UNITED STATES PATENT AND TRADEMARK OFFICE

10/733,260

Office Action Summary	Application No. 10/733,260	Applicant(s) TAKAYAMA ET AL.	
	Examiner ANDRES LOPEZ ESQUERRA	Art Unit 2818

DETAILED ACTION

FIG. 5

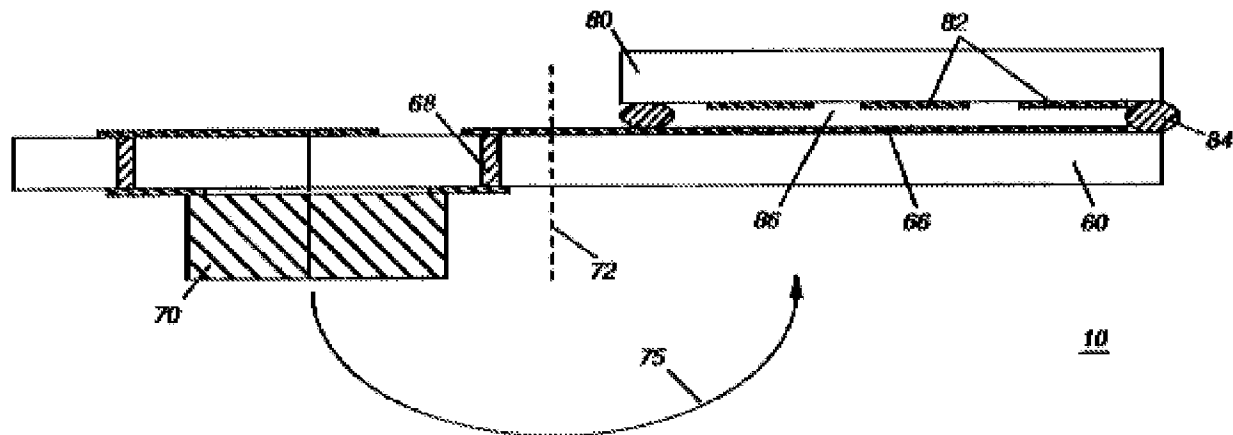
7. As for claims 1 – 2, Arledge discloses (Col. 3, lines 7 - 37) and shows in Fig. 5 a flexible LCD with integrated driver circuit comprising:

- a. a substrate (60) having a contact hole (where the conductive via (68) is preset);
- b. a liquid crystal display device (86) equipped on one side of the substrate;
- and
- c. a thin film integrated circuit (70) equipped on the other side of the substrate, wherein the display device is electrically connected to the thin film integrated circuit through the contact hole (68).

20. As for claims 4 – 5, 7 – 8, 10, and 12, Arledge discloses (Col. 3, lines 7 - 37) and shows in Fig. 5 a flexible LCD with integrated driver circuit comprising:

- h. a substrate (60) having a contact hole (where the conductive via (68) is preset);
- i. a display device (86) equipped on one side of the substrate; and
- j. a thin film integrated circuit (70) equipped on the other side of the substrate, wherein the display device is electrically connected to the thin film integrated circuit through the contact hole (68) making it an active matrix type device since the IC is a driving IC.

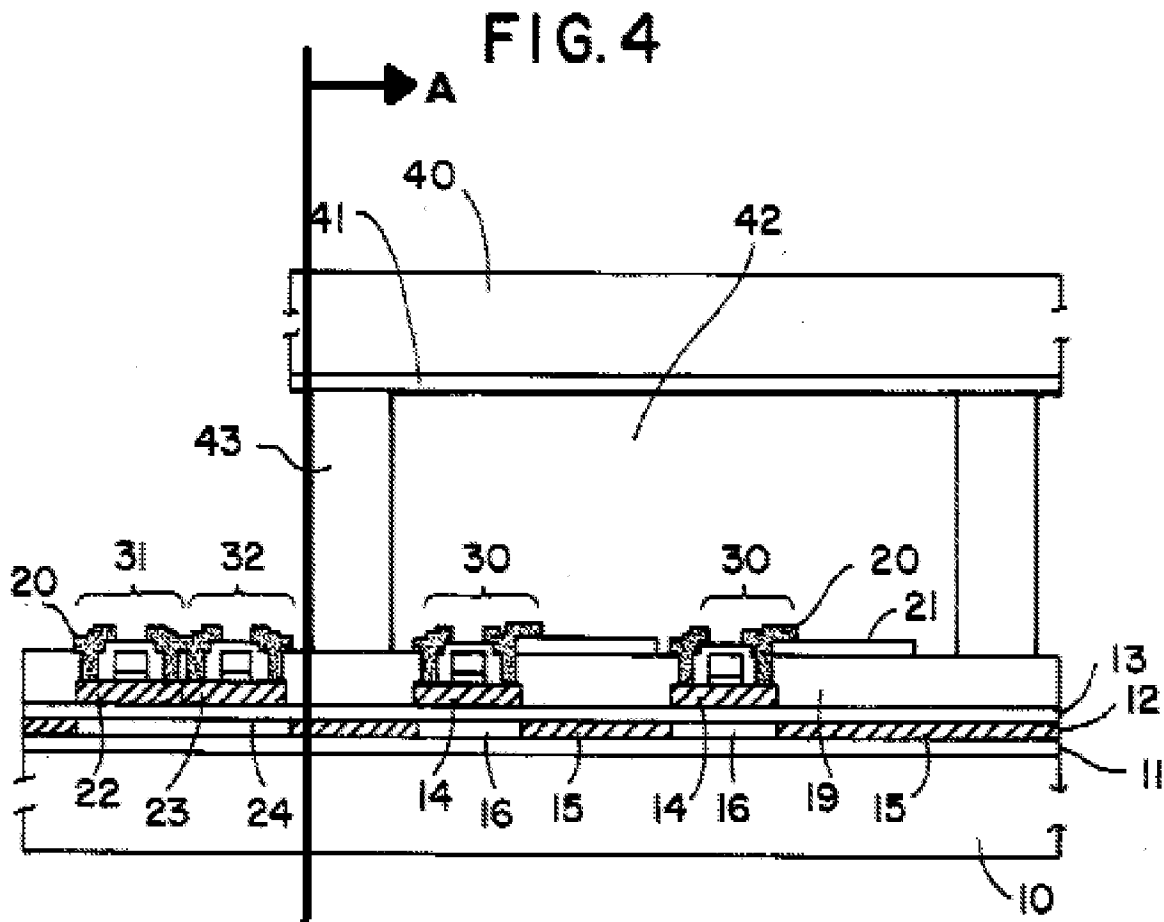
9. Kusumoto discloses (Col. 7, lines 33 – 58, Col. 4, line 10 – 20) and shows in Fig. 4 a LCD display (A) with a peripheral driving circuit (31, 32) where both use a polycrystalline semiconductor layer (14, 22,24) on the construction.

22. Kusumoto discloses (Col. 7, lines 33 – 58, Col. 4, line 10 – 20) and shows in Fig. 4 a LCD display (A) with a peripheral driving circuit (31, 32) where both use a polycrystalline semiconductor layer (14, 22, 24) on the construction.

FIG. 8B

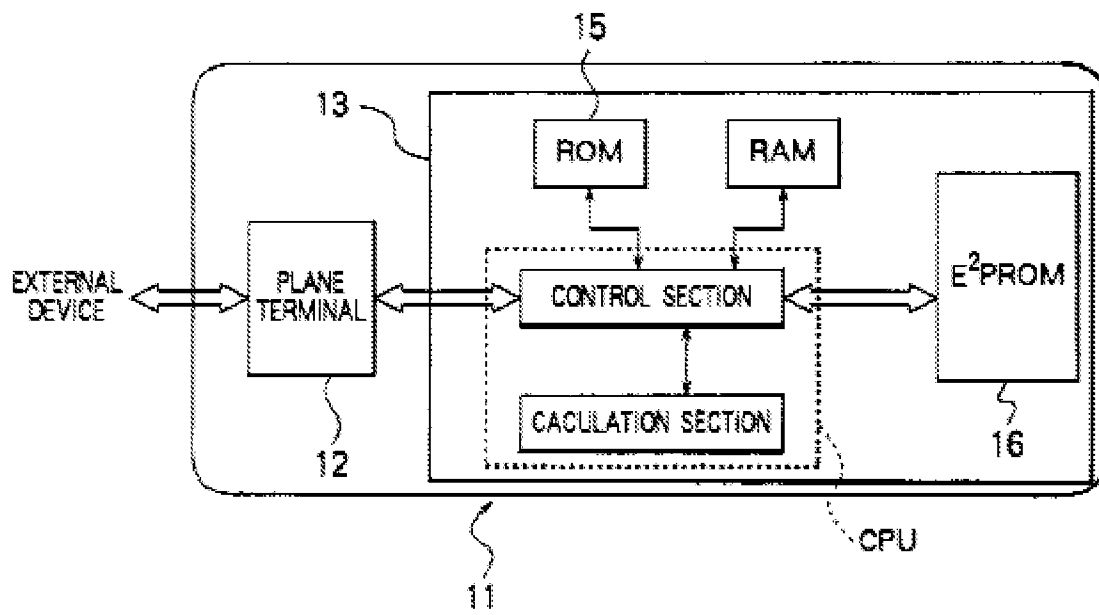
13. Iwasaki discloses (Col. 10, lines 27 - 34) and shows in Fig.8B an IC card (11) that comprises an IC (13) which includes a CPU and a Memory (16, 15).

26. Iwasaki discloses (Col. 10, lines 27 - 34) and shows in Fig. 8B an IC card (11) that comprises an IC (13) which includes a CPU and a Memory (16, 15).

FIG. 3

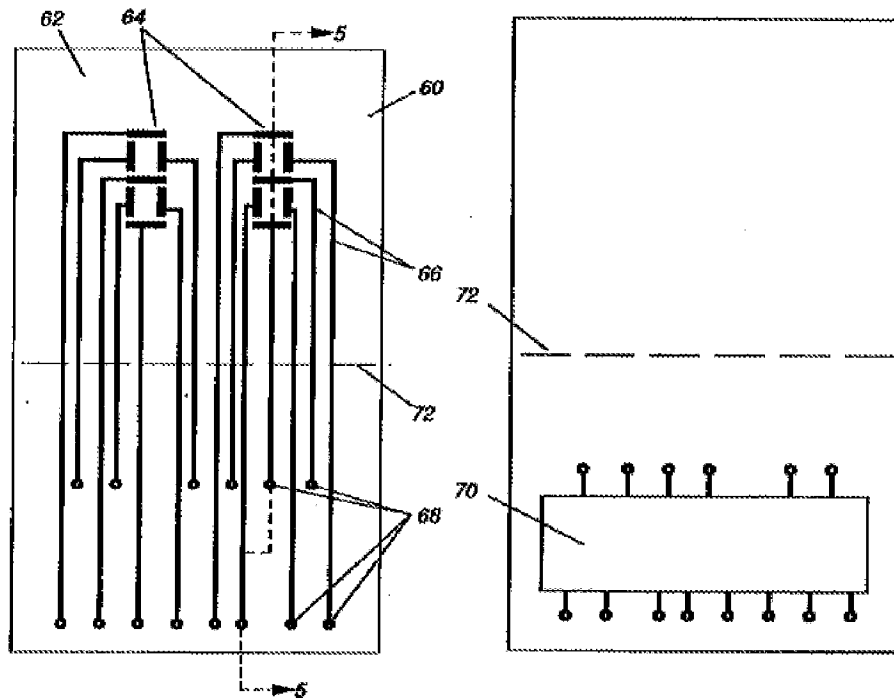
17. As for claim 30, Arledge discloses (Col. 2, lines 46 – 51) and shows in Figs. 3 and 4 the substrate further comprising:

- d. a lead provided on the substrate (top of 68);
- e. a terminal provided in the display device (64);
- f. a first wire electrically connected to the lead and the terminal (66); and,
- g. a second wire electrically connected to the lead and at least one of the pluralities of thin film integrated circuits (Fig.4).

35. As for claims 31 – 33, Arledge discloses (Col. 2, lines 46 – 51) and shows in Figs. 3 and 4 the substrate further comprising:

- k. a lead provided on the substrate (top of 68);
- l. a terminal provided in the display device (64);
- m. a first wire electrically connected to the lead and the terminal (66); and,
- n. a second wire electrically connected to the lead and at least one of the pluralities of thin film integrated circuits (Fig.4).

FIG. 8

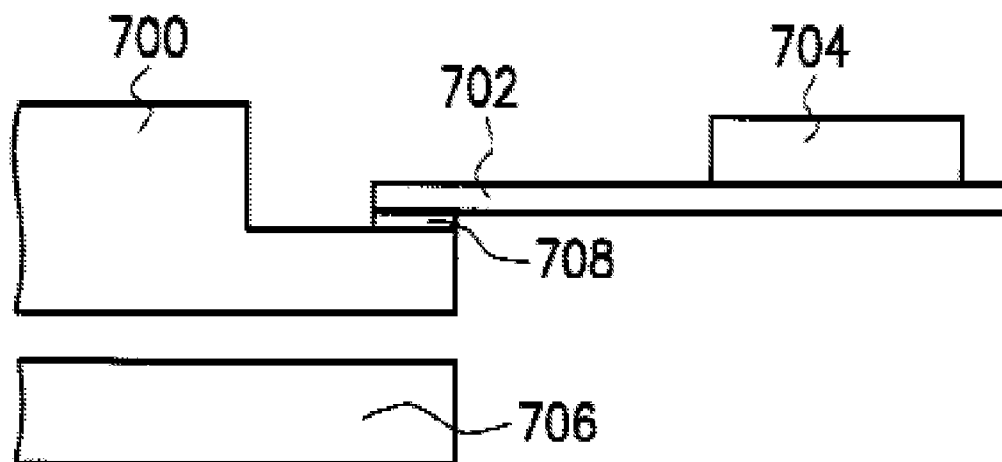
39. Chen discloses (Col. 5, lines 60 – 64) and shows in Fig. 8 the use of an adhesive agent (708) to connect the LCD (700, 706) to the substrate (702).

50. Chen discloses (Col. 5, lines 60 – 64) and shows in Fig. 8 the use of an adhesive agent (708) to connect the LCD (700, 706) to the substrate (702).
